RE: Submittal of Value Engineering Study Report  
Project Task Order No. 7 – Contract TOOESV060196  
Project Jennings Mill Parkway  
**Project No.** STP-F001-00(098) – P.I. Number: 0001098  
**County** Oconee

# Value Engineering Study Report

## Project Jennings Mill Parkway SR 316 to Epps Bridge Road State Aid Project

P.I. No. 0001098  
*STP-F001-00(098)*

DESCRIPTION: **CHANGE FRONTAGE ROAD EAST FROM URBAN SECTION TO RURAL SECTION**

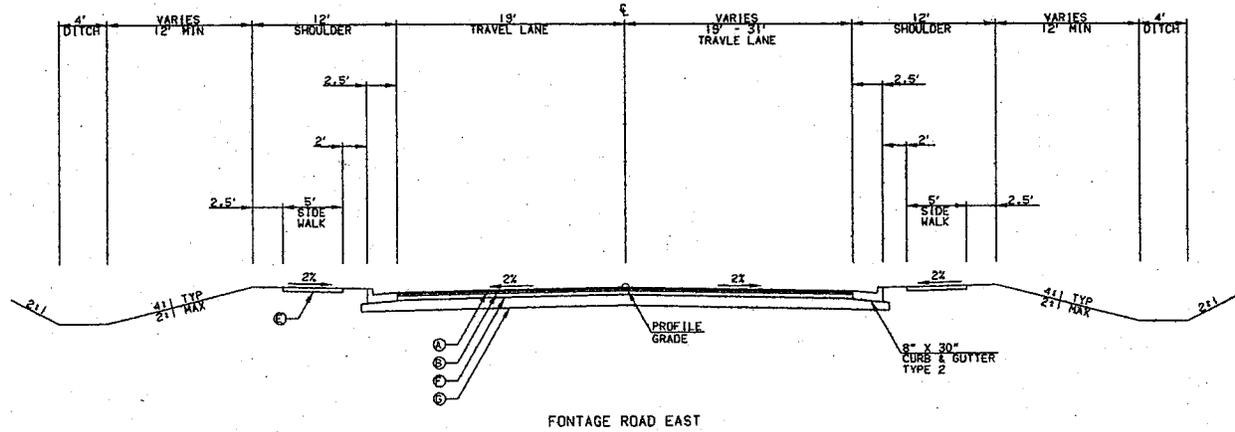
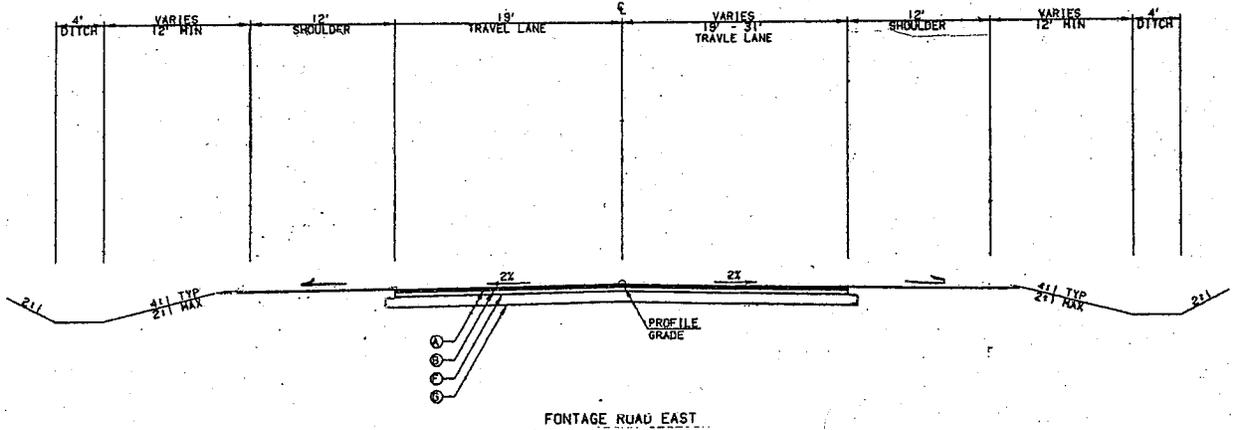
This section of roadway has no development at this time and is similar to other rural sections in the area. As development begins, curb and gutter and drainage would be installed as part of the development.

ORIGINAL DESIGN - URBAN SECTION

ALTERNATE DESIGN - RURAL SECTION

ALTERNATIVE NO.:  
**CI-2**

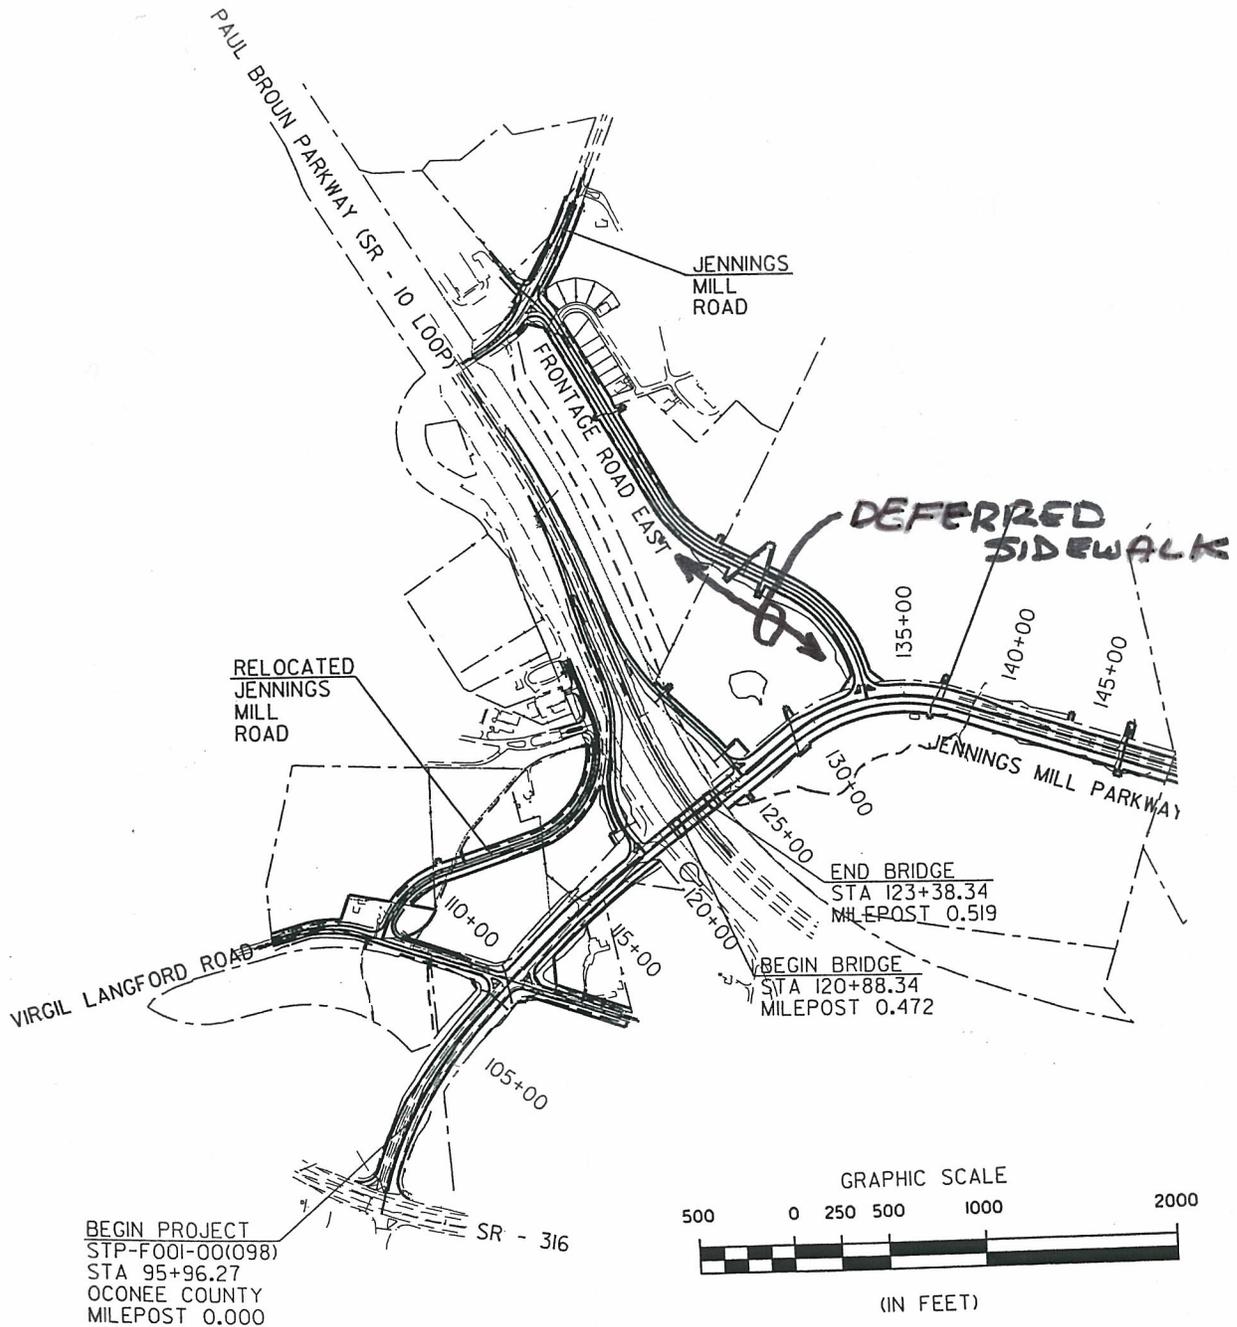
When sidewalks are installed on undeveloped land, often the developers have to tear out much of the sidewalks in order to reconfigure the property frontage to accommodate accel/decal lanes and utilities. Then they have to go to expense of replacing the sidewalks. This alternative could minimize this cost to developers, provide for a reasonable accommodation of the pedestrians with one sidewalk and reduce overall construction cost significantly.

ORIGINAL DESIGN

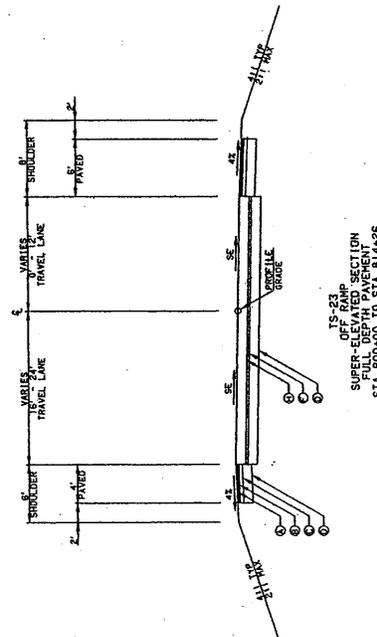
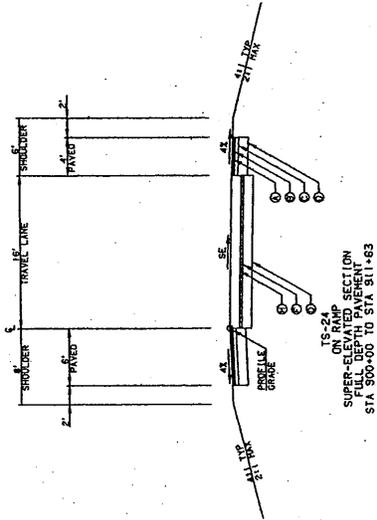
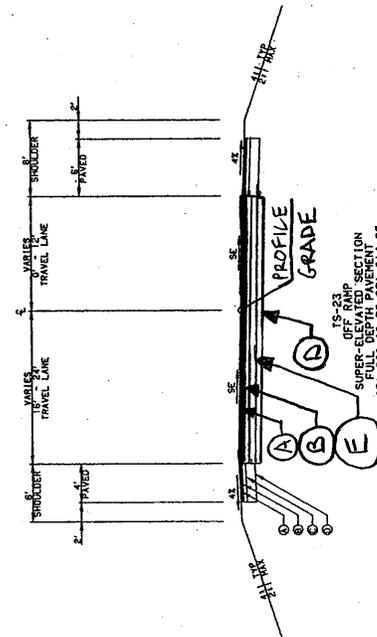
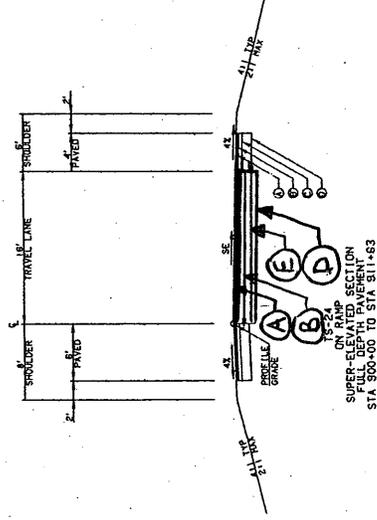
The alternative accomplishes the same function as the original at a reduced cost. In addition, the original design proposes to resurface existing Paul Broun Pkwy/SR10 Loop with asphalt adjacent to the on and off ramps which are originally designed with PC concrete. Using the alternative design and constructing the on and off ramps with asphalt concrete pavement will provide a uniform riding surface.

ALTERNATIVE

DESCRIPTION: RELOCATE BICYCLE LANES

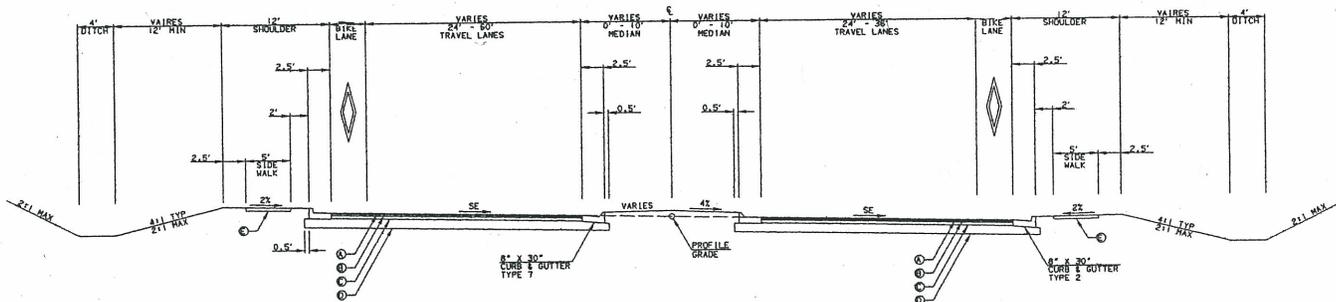
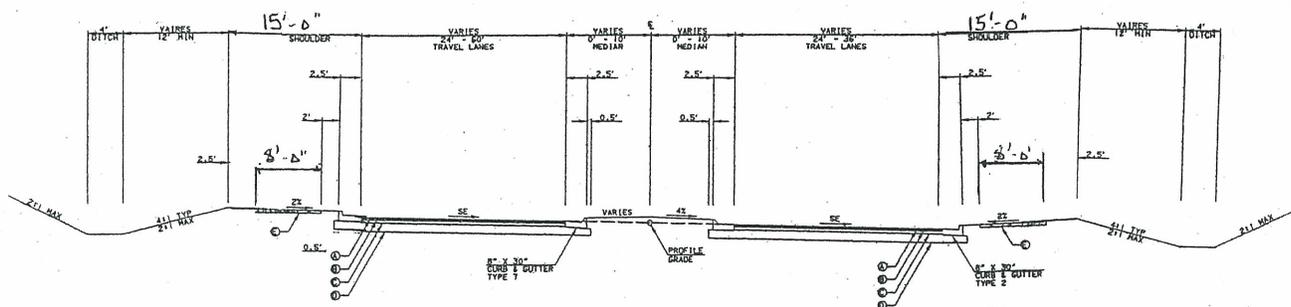
Access for alternative transportation (bicycles, pedestrians, etc.) is beneficial. Utilization of a multi use trail allows safer and varied usage. Trails can be constructed away from the roadway and become part of a larger system.

ORIGINAL DESIGN  
BIKE LANE AS PART OF PAVED TRAVELWAY

ALTERNATE DESIGN  
MULTI-USE TRAIL ON SHOULDER

DESCRIPTION: REDUCE PAVEMENT WIDTH ON FRONTAGE ROAD EAST SHEET NO.: 3 of 5

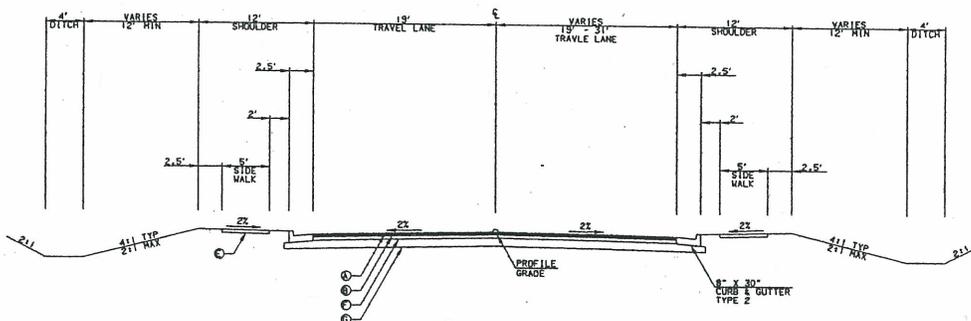
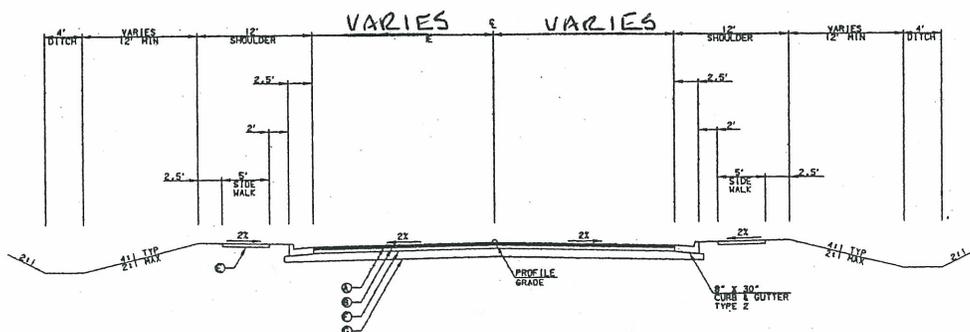
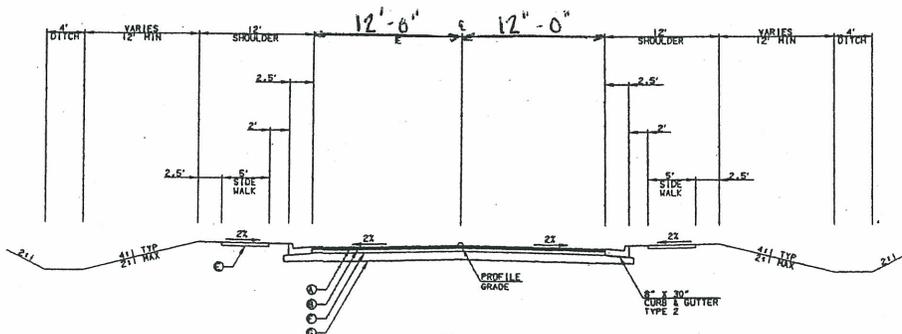
The roadway width of 24 feet will be satisfactory without the middle/turn lane. There are no developments along this road therefore no turn lanes are currently required.

ORIGINAL DESIGN - FRONTAGE ROAD EAST

ALTERNATE DESIGN - FRONTAGE ROAD EAST  
 STA 400+00 - STA 406+45  
 STA 424+55 - STA 430+00

ALTERNATE DESIGN - FRONTAGE ROAD EAST  
 STA 406+45 - STA 424+55

DESCRIPTION: ELIMINATE END SPANS & USE WALLED ABUTMENTS SHEET NO.: 2 of 6

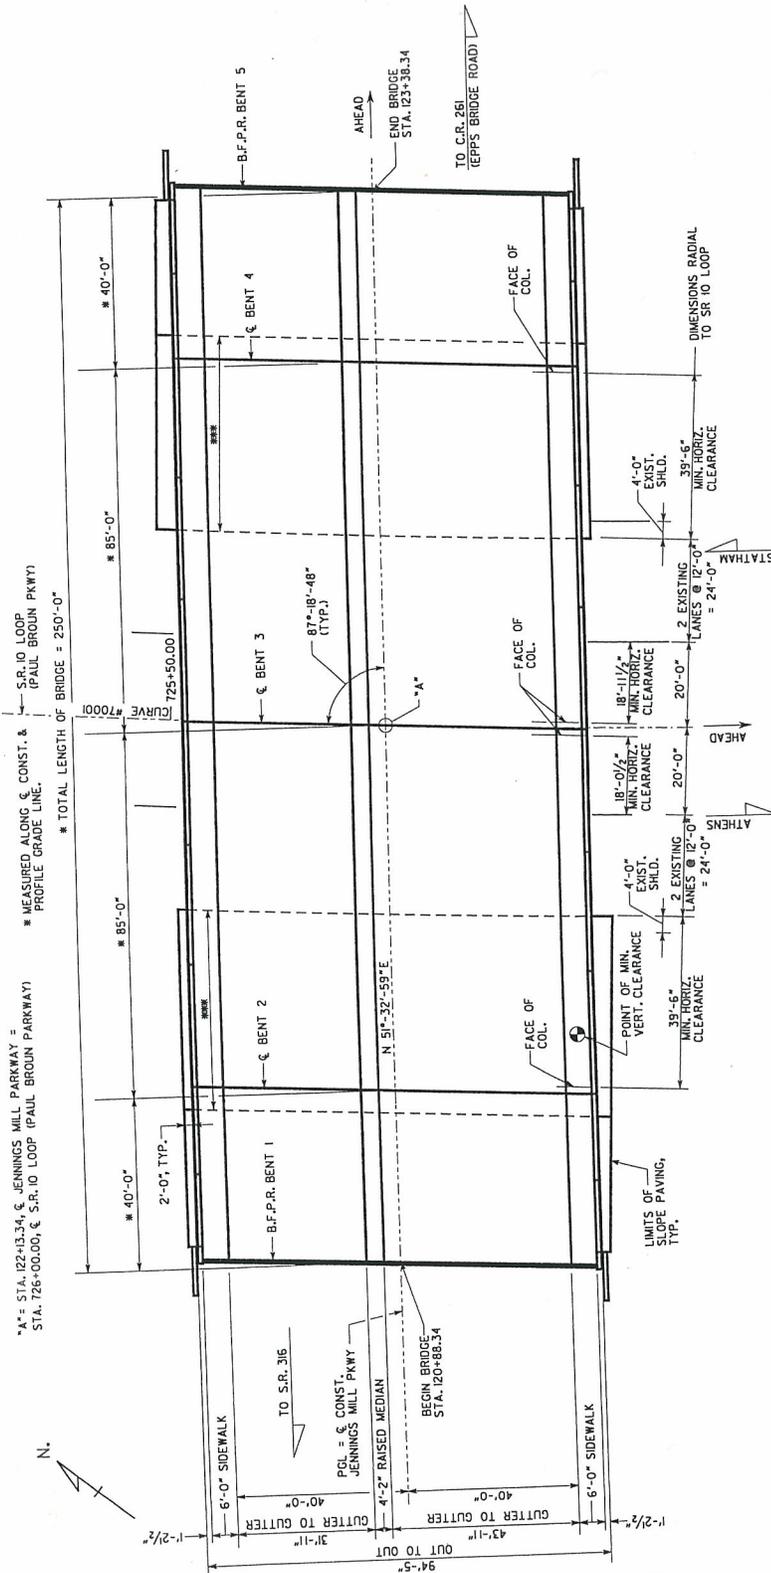
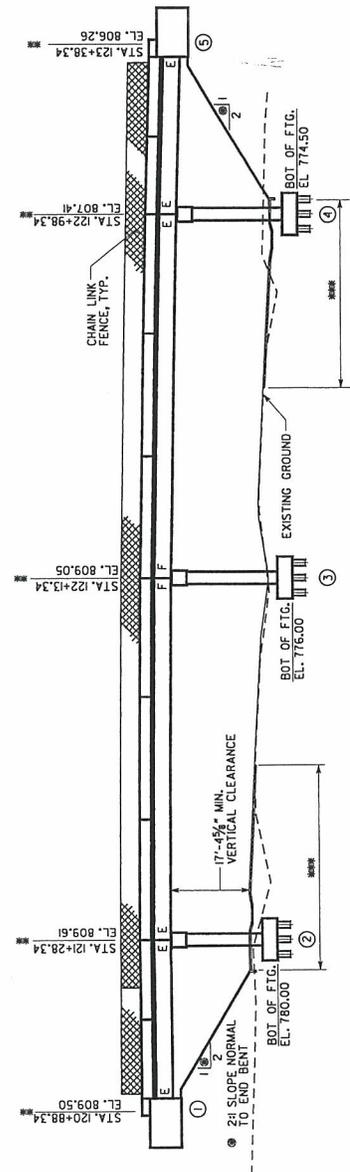
The original 4-span bridge is 250' long with 40' end spans and 85' intermediate spans. The bridge is on a vertical curve. End spans 1 and 4 consist of nine 40' Modified Type I PSC beams with Type III PSC Fascia beams evenly spaced. Spans 2 and 3 consist of sixteen Type III PSC beams evenly spaced. The out-to-out width of the bridge is 94'-5". The bridge accommodates a 6' raised sidewalk, 2' buffer and 4' Bike Lane on both sides of the bridge, two 12' travel lanes in each direction, a 12' turn lane on the south side of the bridge, a 4' raised median with a 2' buffer on either side. The bents are made up of concrete caps and columns. The end bents and intermediate bents are founded on PSC Piles.

ALTERNATIVE NO.: BI-2

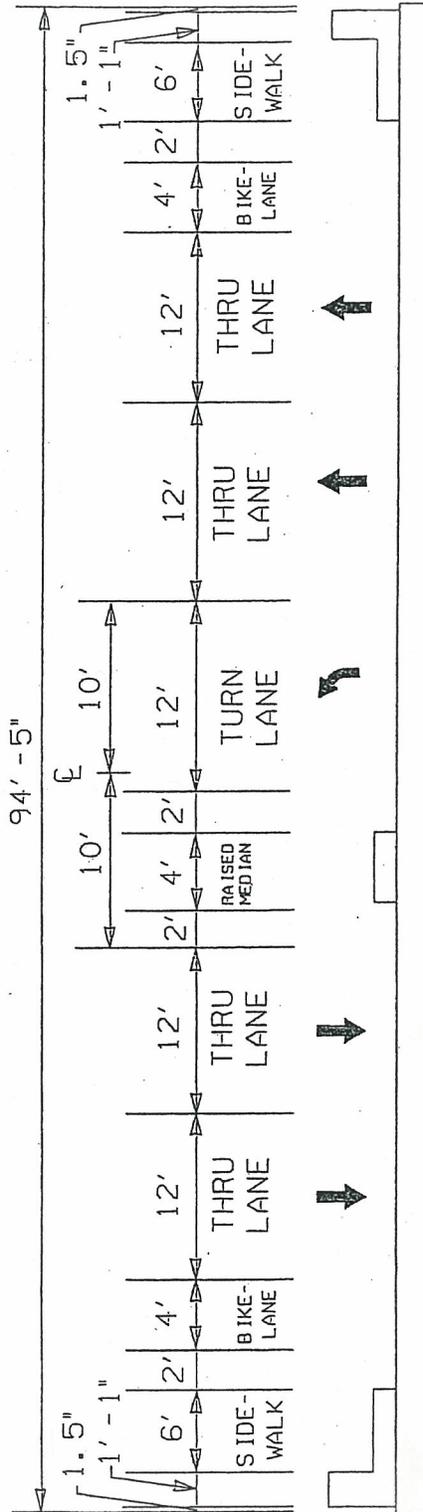
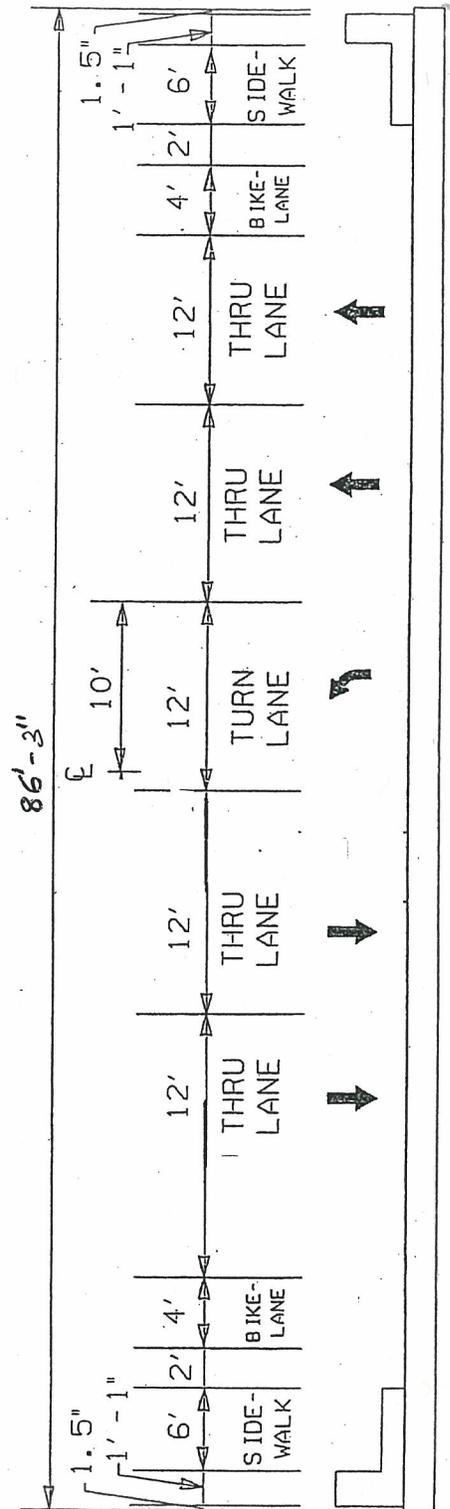
Removing the median reduces the bridge width by approximately 8'-2" (4'-2" median + 2\*2' buffer on either side of the median). The resulting bridge cross section will comprise of eight 40' Modified Type I PSC beams with Type III PSC Fascia beams evenly spaced for end spans 1 and 2 and fifteen Type III PSC beams evenly spaced for intermediate spans 2 and 3. The out-to-out width of the bridge will be 86'-3". Additionally, the substructure will be comprised of reduced cap lengths.

JENNINGS MILL PKWY  
BRIDGE TYPICAL SECTION

JENNINGS MILL PKWY  
BRIDGE TYPICAL SECTION

ALTERNATIVE NO.: BI-6

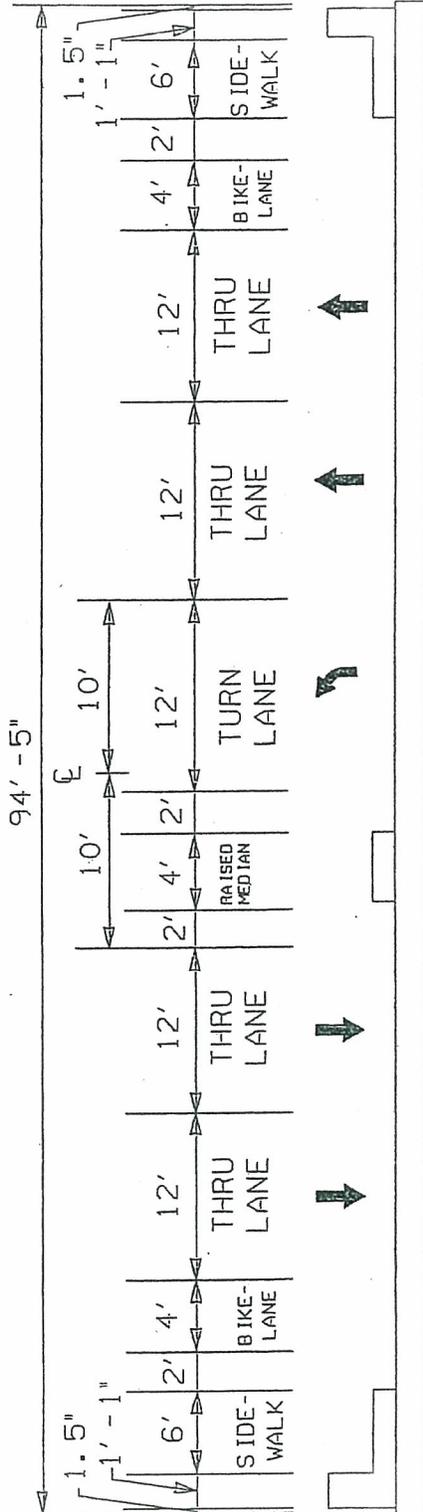
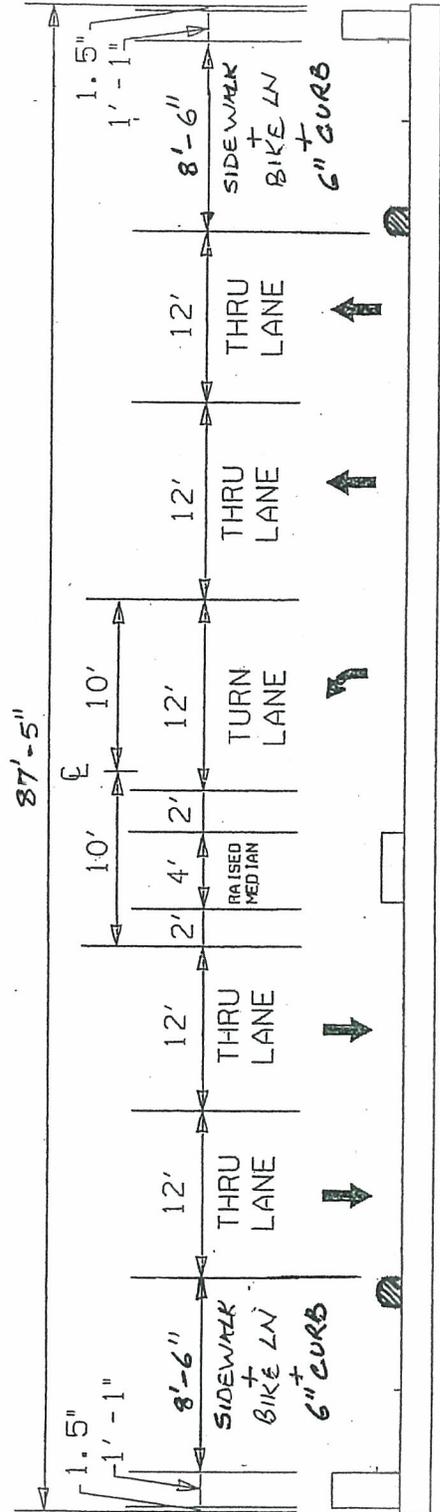
A 6" safety curb may be provided between the edge of travel lane and sidewalk/bike lane. Combining the Sidewalk and Bike Lane for a width of 8'-6" (8' combined sidewalk and bike lane + 6" curb) on each side of the bridge reduces the total bridge width by approximately 7'. The resulting bridge cross section will comprise of eight 40' Modified Type I PSC beams with Type III PSC Fascia beams evenly spaced for end spans 1 and 2 and fifteen Type III PSC beams evenly spaced for intermediate spans 2 and 3. The out-to-out width of the bridge will be 87'-5". Additionally, the substructure will be comprised of reduced cap lengths.

JENNINGS MILL PKWY  
 BRIDGE TYPICAL SECTION  
 (ORIGINAL)

JENNINGS MILL PKWY  
 BRIDGE TYPICAL SECTION  
 (ALTERNATIVE)
